Access Compliance Report
Public Rights-of-Way
(Curb Ramps)

Intersection ID: 13654	**Main Street: S_TRYON_ST**	**Cross Street: W_PARK_AV**	**Location: S**
ADA ID: 0840A38B6FDD	**Ramp Type: Perp**	**Initial Pass/Fail: Fail**	**Overall Compliance: No** / **Severity Score: 13.75**

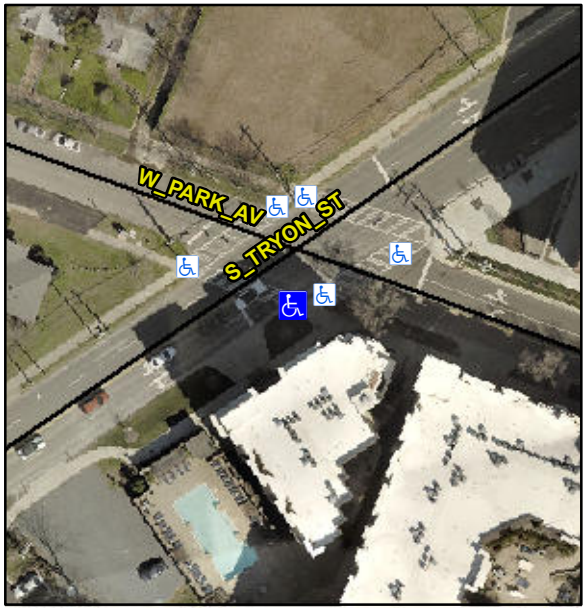
R304.2.2

Compliance	Description	Data	Compliance	Description	Data
N/A	Ramp Length (in)	27.0	No	Ramp Slope (%)	10.9
Yes	Ramp Width (in)	106.0	Yes	Ramp XSlope (%)	3.2
N/A	Flare Type LT	N/A	N/A	Flare Type RT	N/A
N/A	Flare Slope LT (%)	N/A	N/A	Flare Slope RT (%)	N/A
N/A	Flare Traversable LT?	N/A	N/A	Flare Traversable RT?	N/A
N/A	Landing Length (in)	N/A	N/A	DWS Provided?	N/A
N/A	Landing Width (in)	N/A	N/A	DWS Contrast?	N/A
N/A	Landing Slope (%)	N/A	N/A	DWS Length (in)	N/A
N/A	Landing X Slope (%)	N/A	N/A	DWS Full Width?	N/A
N/A	Landing Curb? (Y/N)	N/A	N/A	DWS Offset (in)	N/A
N/A	Shared Landing?	N/A			
N/A	Gutter Ponding?	N/A	N/A	Gutter Slope (%)	N/A
N/A	Gutter Lip Ht (in)	N/A	N/A	Gutter X Slope (%)	N/A
N/A	Painted X Walk1?	Yes	N/A	Painted X Walk2?	N/A
	X Walk 1 Direction	To NW		X Walk 2 Direction	N/A
N/A	X Walk 1 Width (in)	111.0	N/A	X Walk 2 Width (in)	N/A
	X Walk 1 Slope (%)	4.3		X Walk 2 Slope (%)	N/A

Remove & Replace Entire Ramp.
